Access Compliance Report

(Curb Ramps)

Intersection ID: 6698	Main Street: CATHEY_RD	Cross Street: TOM_SADLER_RD	Location:	N/A
ADA ID: 78CA6A0AFAF6	Ramp Type: Perp	Initial Pass/Fail: Fail	Overall Compliance: No	Severity Score: 12.5
Codes/Mitigation Info/Possible Solution		Field Measurements/Component Compliance

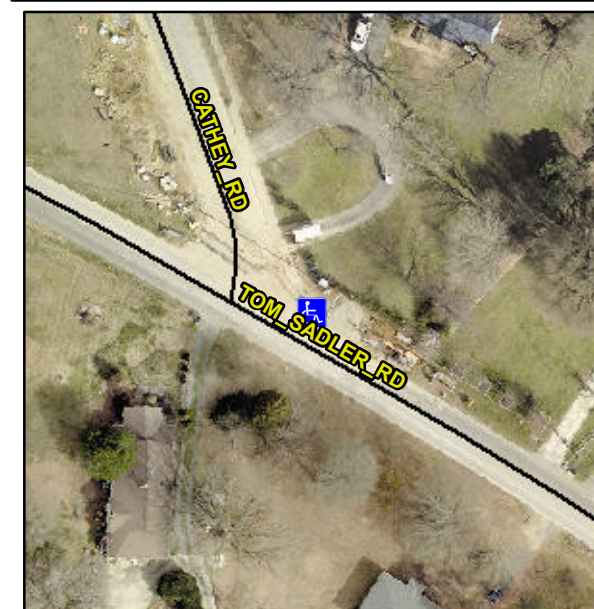
Not Found, R304.2.2

Compliance	Description	Data	Compliance	Description	Data
N/A	Ramp Length (in)	59.5	No	Ramp Slope (%)	10.0
Yes	Ramp Width (in)	48.0	Yes	Ramp XSlope (%)	1.6
N/A	Flare Type LT	N/A	N/A	Flare Type RT	N/A
N/A	Flare Slope LT (%)	N/A	N/A	Flare Slope RT (%)	N/A
N/A	Flare Traversable LT?	N/A	N/A	Flare Traversable RT?	N/A
N/A	Landing Length (in)	N/A	N/A	DWS Provided?	N/A
N/A	Landing Width (in)	N/A	N/A	DWS Contrast?	N/A
N/A	Landing Slope (%)	N/A	N/A	DWS Length (in)	N/A
N/A	Landing X Slope (%)	N/A	N/A	DWS Full Width?	N/A
N/A	Landing Curb? (Y/N)	N/A	N/A	DWS Offset (in)	N/A
N/A	Shared Landing?	N/A			
N/A	Gutter Ponding?	N/A	N/A	Gutter Slope (%)	N/A
N/A	Gutter Lip Ht (in)	N/A	N/A	Gutter X Slope (%)	N/A
N/A	Painted X Walk1?	No	N/A	Painted X Walk2?	N/A
	X Walk 1 Direction	To S		X Walk 2 Direction	N/A
N/A	X Walk 1 Width (in)	N/A	N/A	X Walk 2 Width (in)	N/A
	X Walk 1 Slope (%)	1.6		X Walk 2 Slope (%)	N/A
	X Walk 1 X Slope (%)	2.0		X Walk 2 X Slope (%)	N/A

Remove & Replace Entire Ramp.
